Campaign Service BULLETIN

BULLETIN NUMBER:
CB21-J-003

VOLUNTARY EMISSIONS RECALL **IMPORTANT ENGINE INFORMATION (IEI)** **EMISSIONS LABEL – V21072**

- 2020-2021MY Isuzu N-Series Tilt Cab Vehicles Produced Before 5/18/2021 and Equipped with 6.6L (L8T) Gasoline Engines

Figure 1 – Oil Pan Location

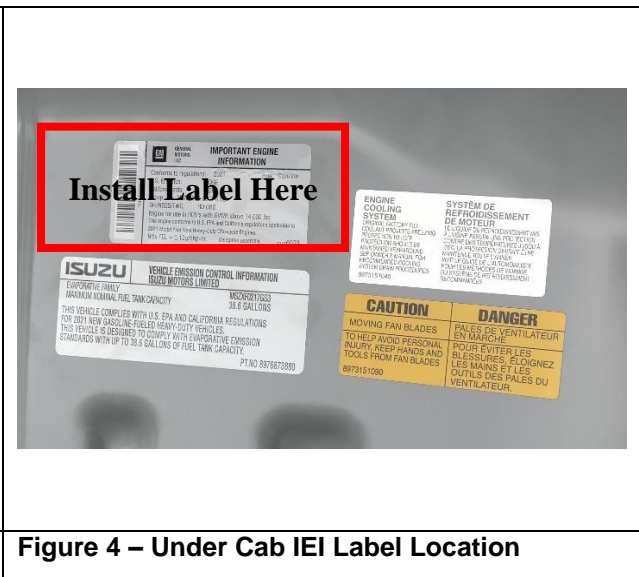
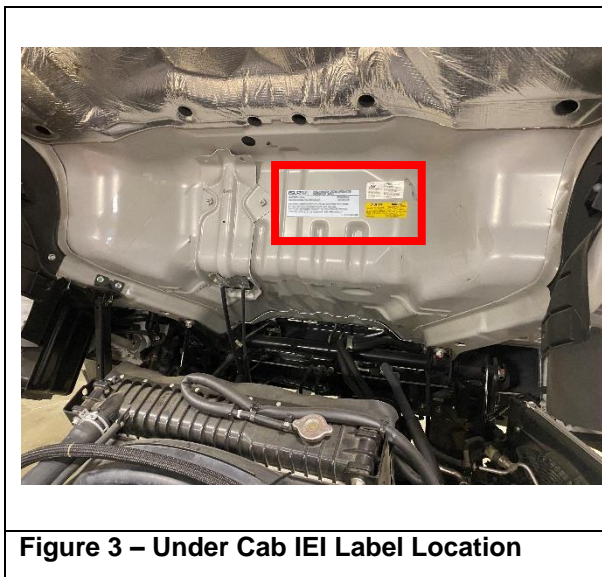
Isuzu Commercial Truck of America, Inc. is conducting a voluntary emissions recall involving certain 2020-2021 model year Isuzu N-Series tilt cab trucks produced before 5/18/2021 and equipped with 6.6L (L8T) gasoline engines. The Important Engine Information (IEI) emissions label does not meet all regulatory requirements.

Dealers will remove the existing IEI label and install one (1) new IEI label on the oil pan and one (1) new IEI label on the cab.

1. Lift the vehicle per the instructions in the applicable Work Shop Manual (WSM).
2. Clean the indicated area on the bottom of the oil pan with isopropyl alcohol and dry with a clean, lint free cloth. The receiving surface must be clean, dry, and free of any contaminants. (See Figure 1.)

3. Install a **NEW** Important Engine Information (IEI) label on the location indicated in Figure 1 at the bottom of the oil pan.
4. Lower the vehicle per the instructions in the applicable WSM.
5. Safely tilt the cab and insert the safety pin per the instructions in the applicable WSM.
6. Remove the old IEI label from the rear of the intake manifold. (See Figure 2.)
